**Cub Cadet****Power Equipment****Service Bulletin****CC-329****LAWN TRACTORS & SERIES 2000**

Models: 2130, 2135, 2150, 2155

Date: June 1, 1996

Subject: AIR CLEANER KIT 759-3801

**Old Design**

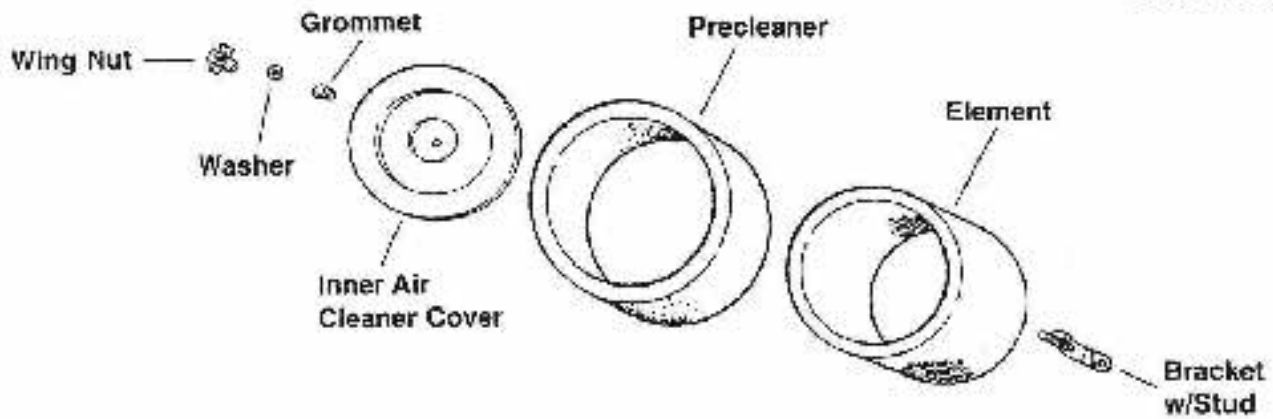
A product improvement has been incorporated in the air cleaner system used on Kohler CH single cylinder engines. The original design had a rubber grommet inserted in the center of the inner air cleaner cover, with a washer and wing nut used for retention. Reports from the field indicated that customers often lost the separate washer and the grommet was being dislodged or damaged by sliding it over the threaded stud.

The new design addresses both problems. The washer and grommet have been replaced by a rubber seal (part number KH-24-032-03), which is installed on the stud under the inner cover. When the pieces are correctly installed, the seal prevents any dirt entry at the stud hole. Normal air cleaner service can be performed without disturbing the seal, so it shouldn't get lost or damaged.

- a. If you have the old design, remove the washer, inner cover, and element/precleaner. Remove the grommet from the inner cover and discard the grommet and washer. Install the new seal on the stud of the air cleaner cover and slide it down against the bracket.

- b. If you have the new design, remove the inner cover and element/precleaner. Inspect the seal on the bracket stud. If it shows any sign of wear or damage, replace it with the new one.
